Technical Service Bulletin

MODEL(S) AFFECTED: **Tennant T1, T1B, E5 and R3**

SUBJECT: Recovery tank ball-float filter prematurely activates and/or machine has poor vacuum suction. This may be caused by the motor shroud not being positioned properly.

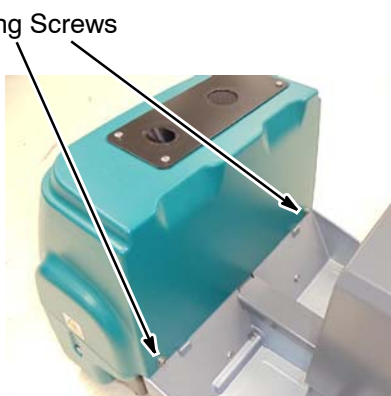
PURPOSE: If motor shroud is slightly raised as shown below, the tank gaskets will not form the proper seal with the solution tanks when cover is lowered.

Shroud not properly seated.
Gap can be as little as 1/16"
(1.5 mm).

When replacing motor shroud, make sure the shroud is completely resting on the frame. The vacuum exhaust muffler may prevent cover from being completely lowered. Before tightening screws, apply downward pressure on shroud to ensure proper installation.

Shroud properly seated.

If the above procedure does not fix the problem check the following:

1. Tanks may not be seated in machine properly.
2. Machine cover may be warped or not centered over tanks.
3. Tank gaskets may be worn or damaged.
